Environmental Baseline Survey Report

Camp Bonneville, Washington

Prepared for U.S. Army Corps of Engineers Seattle District

# APPENDIX A COMMENT RESPONSE PACKAGE

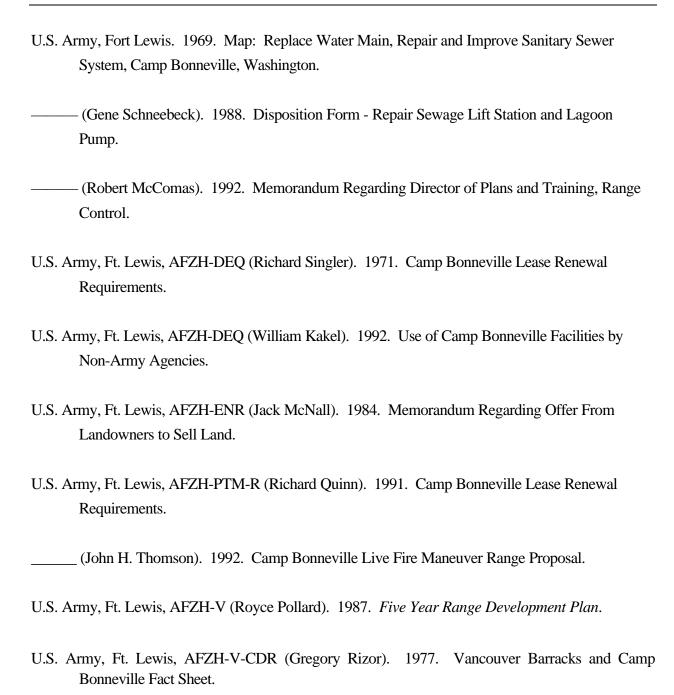
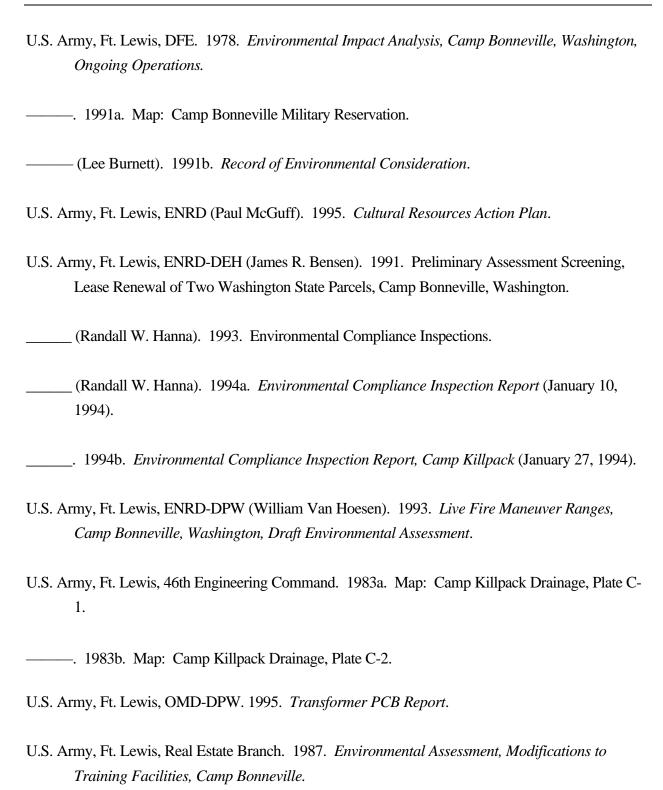
6. Figure 5-1, BRAC Parcel Label Descriptions, Legend: Recommend changing symbol for creeks to differentiate them from roads (denser pattern, possibly alternating dots and dashes [light]).

7. Figure 5-1, BRAC Parcel Label Descriptions, Installation Property Boundary: Symbol does not match what is shown on the map.

4) Section Five, Figure 5-1; This (and other) figures is not easily to read. Creeks and roads are difficult to identify. Recommend making figures clearer and more legible in the future.

2. Pages 3-3 through 3-8. Should there be a map showing the location of each structure listed on the Tables? I think it would make it clearer. The insets on Figure 5-1 are not that readable because the print is small.

Additional maps can be provided by Woodward-Clyde at the request of the USACE. However, displaying the locations of all the structures mentioned on pages 3-3 through 3-8 on the maps in this report is not necessary for the purposes of the EBS. Font size in the insets of Figure 5-1 has been increased for readability.
